CITY OF PORTLAND

Permit Number: 061495

Thi	s is to certify that	——————————————————————————————————————		5 / TVIGING	***************************************			
has	permission to	Remove nonconforming sun	m and d		a 20'7" x		deck with an15' x 11' sunroom on the deck.	
ΑT	75 DEEPWOOD	DR				4	. 397 C012001	
	<u>-</u>							_

CITY OF PORTLAND NOTICE OF VIOLATION

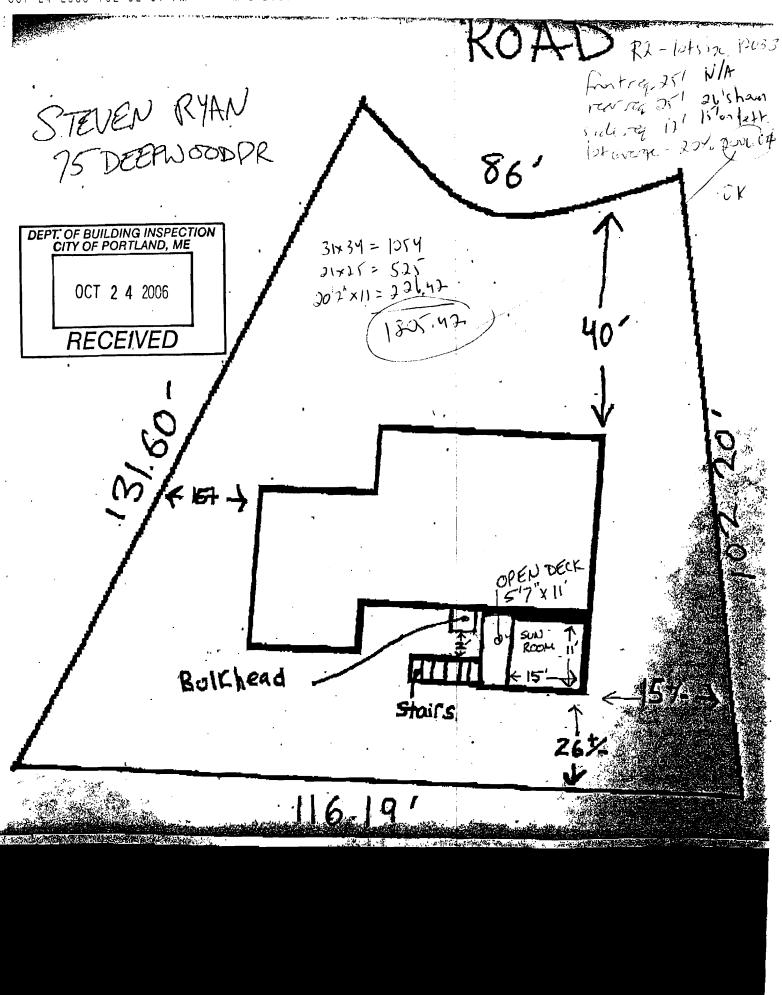
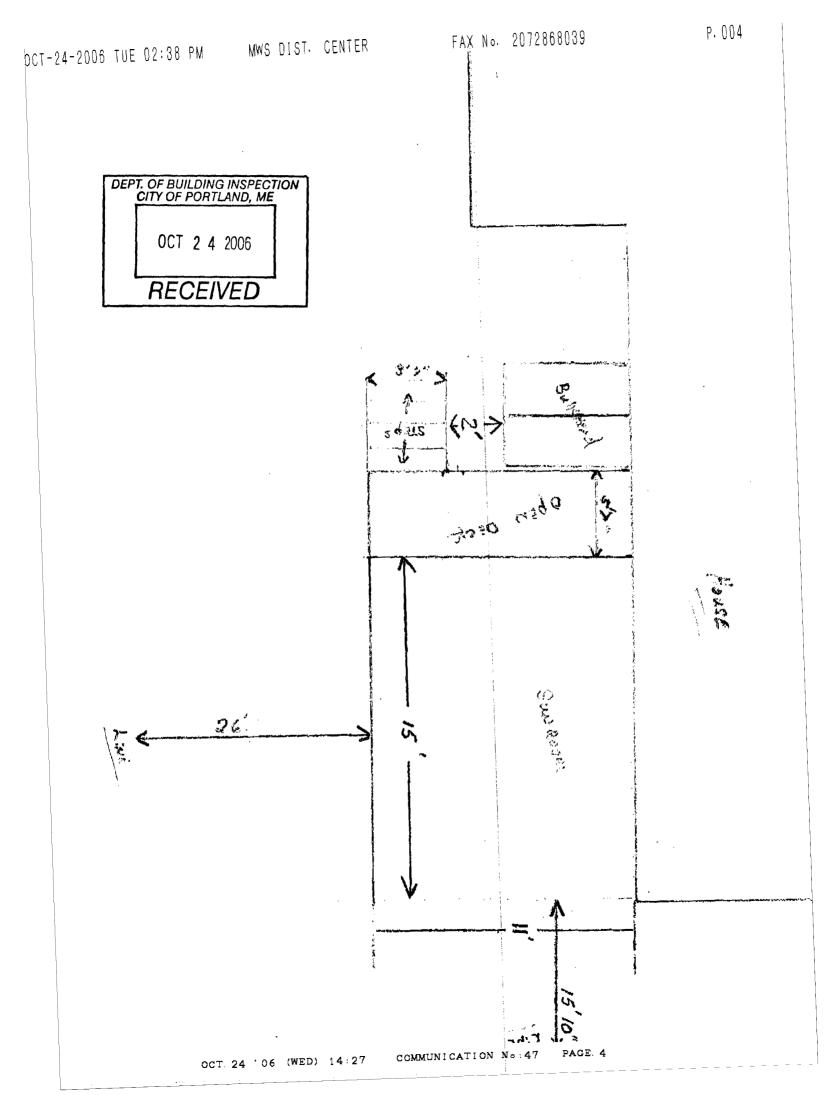
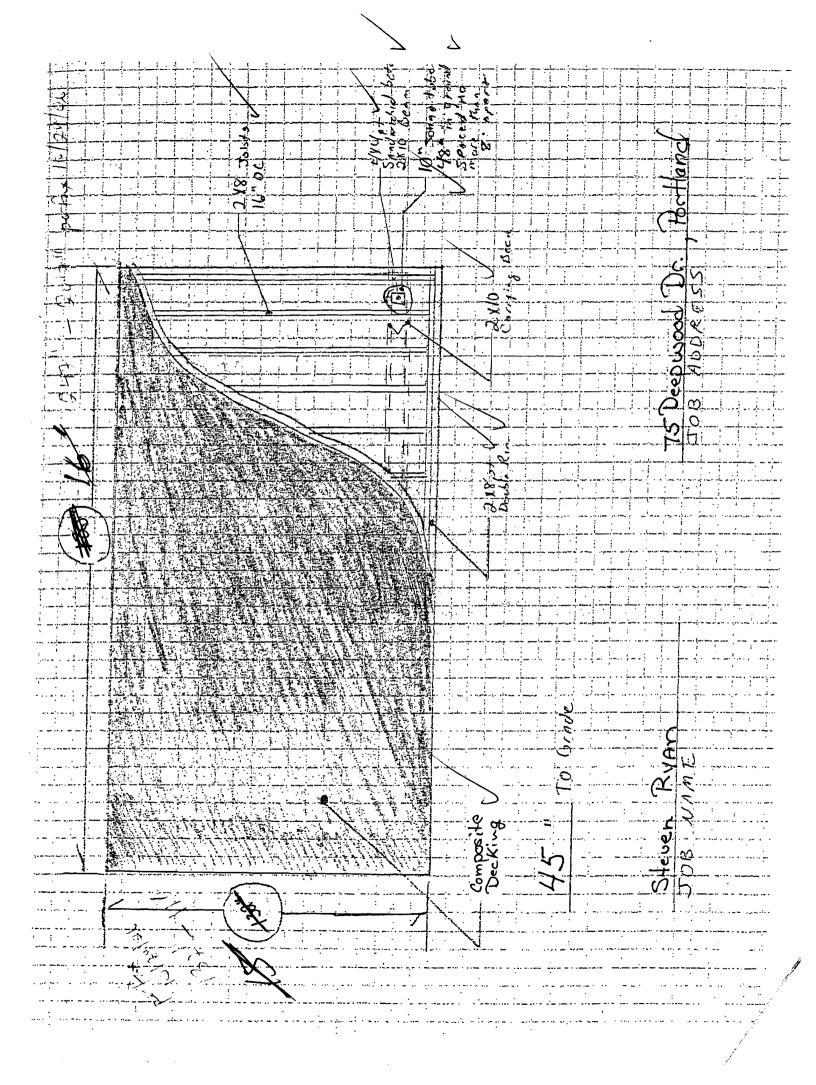
10/24/2006-amachado: Left message with Erin Fogg at True North Home Systems. Permit 06-1006 was issued in july for a 11'x 15' deck to replace a 21' x 15' deck that did not meet zoning requirements. Now this permit proposes a deck that comes off the house 15' and would leave a 21' setback instead of the 25' required.

of I have revised the plot plan + permit ap. to reflect that the deck is 20'7"x11', and the sun room is 15'x11'. I don't know where the "15'x16" numbers came from or who scratched out the original numbers (which were reversed.)

10/24/2006-amachado: Erin Fogg submitted a revised application and site plan that meets the zoning requirements.
